TRANS/WP.29/GRE/2003/6  
27 January 2003

World Forum for Harmonization of Vehicle Regulations (WP.29)

Working Party on Lighting and Light-Signalling (GRE)

PROPOSAL FOR COLLECTIVE AMENDMENTS TO  
REGULATIONS Nos. 3, 6, 50, 65 and 91

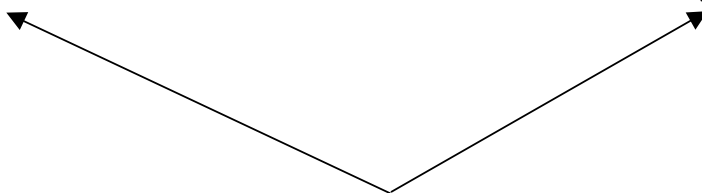
An error has been made and the "less than or equal to" sign following the letter "y" should be removed and replaced by a "greater than or equal to" sign.

The following problem has arisen with the amendment to the Regulations for the amber colour box. As is demonstrated below the wrong area is described.

Area A defined by amendment to Regulations  
 $y \geq 0.39$   
 $y \leq x - 0.12$   
 $y \leq 0.79 - 0.67x$

NEW area defined by  
 $y \geq 0.39$   
 $y \leq x - 0.12$   
 $y \geq 0.79 - 0.67x$

Note the difference  
 This means that area A in the Regulations is not NEW as was intended

**For the future, GRE may want to consider replacing the "less than" or "greater than" signs with an "equals" sign to remove the possibility for confusion. This is also more correct in line with the terminology used – "the limit towards white". A limit is a line ( $y = \dots$ ) and not a half plane.**
